BUILDINGS 5 & 6 RENOVATIONS
San Mateo County Community College District

CAÑADA COLLEGE
4200 Farm Hill Boulevard
Redwood City, CA 94061

FIRST FLOOR PLAN

Date: 08/29/08
Scale: AS NOTED
Project Number: 07013
Drawing Number: A2.1

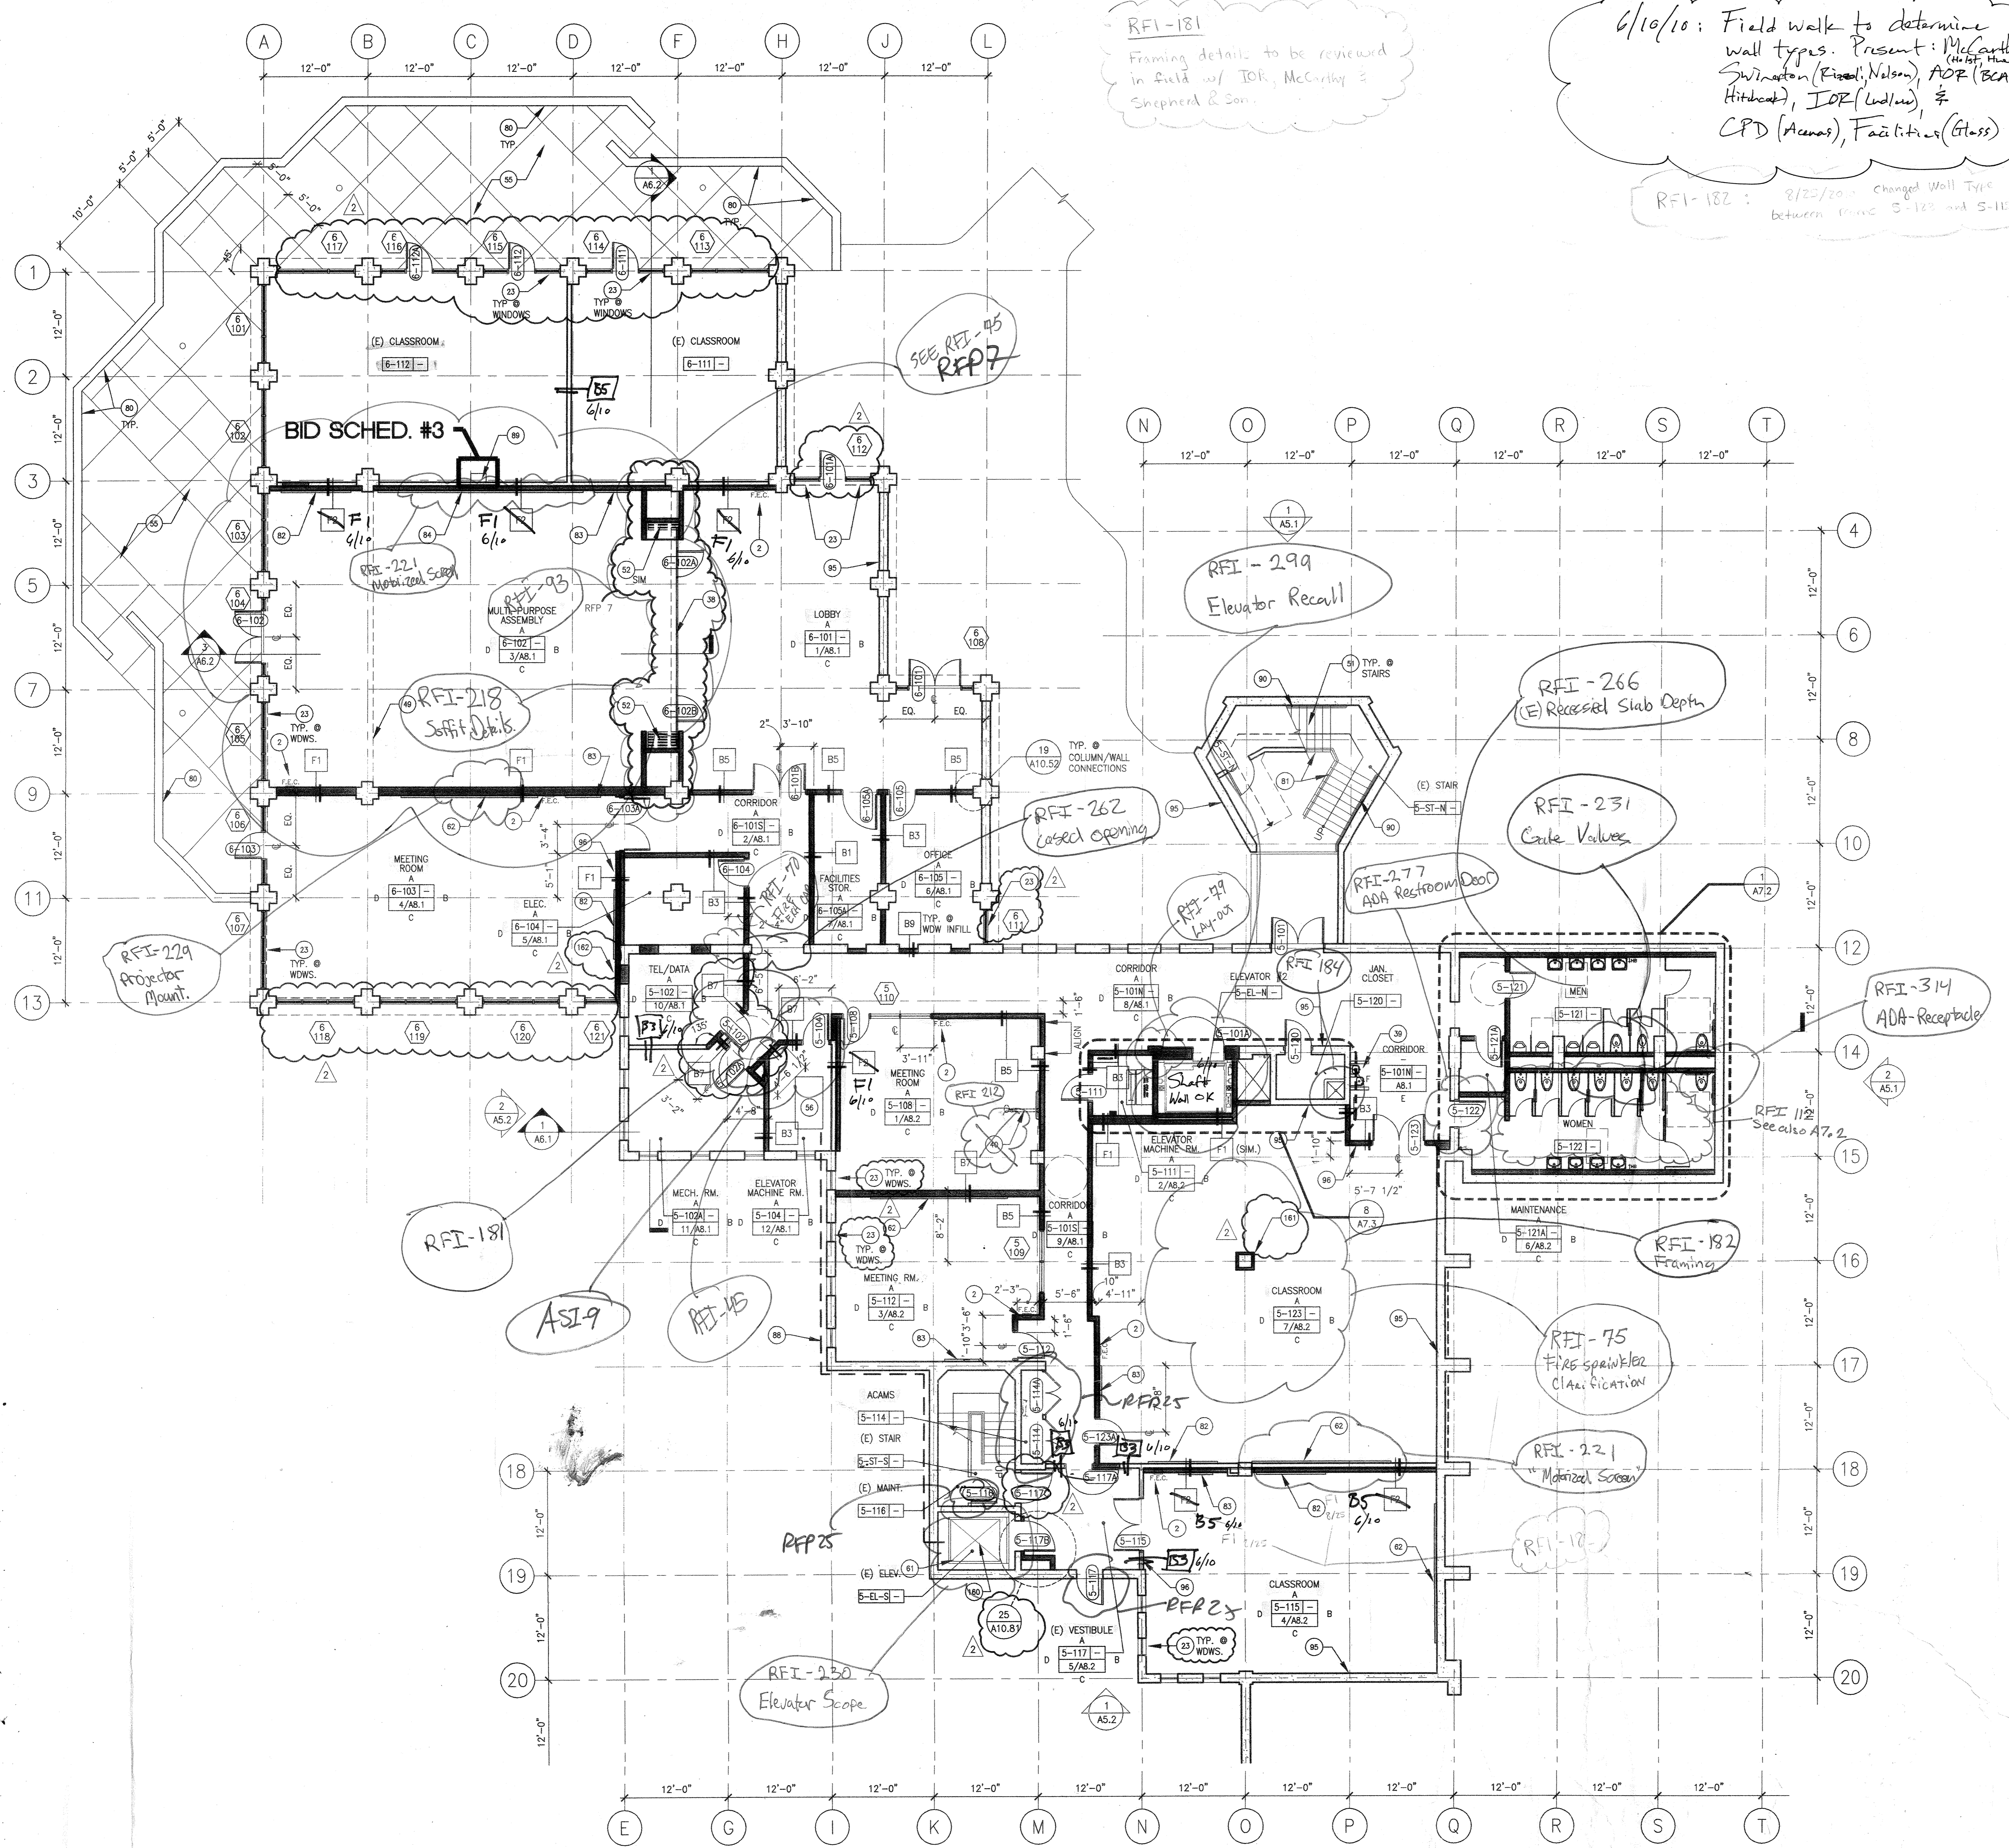
SEE RFI-25
EXISTING DOORS

RFI-181
Framing details to be reviewed in field w/ TOR, McCarthy & Shepherd & Son.

6/10/10: Field walk to determine wall types. Present: McCarthy (Hrist, Hrist), Swinson (Kissel, Nelson), ADP (BCA, Hiltihead), IDP (Ludlow), CPD (Acuras), Facilities (Glass)
RFI-182: 8/22/09: changed Wall Type between lines 5-122 and 5-110

SEE RFI-45
RFP7

RFI-299
Elevator Recall

RFI-266
(E) Recessed Slab Depth

RFI-231
Cook Valves

RFI-277
ADA Restroom Door

RFI-314
ADA Receptacle

RFI-192
Framing

RFI-75
Fire Sprinkler Classification

RFI-221
Material Screen

RFI-230
Elevator Scope

RFI-229
Projector Mount.
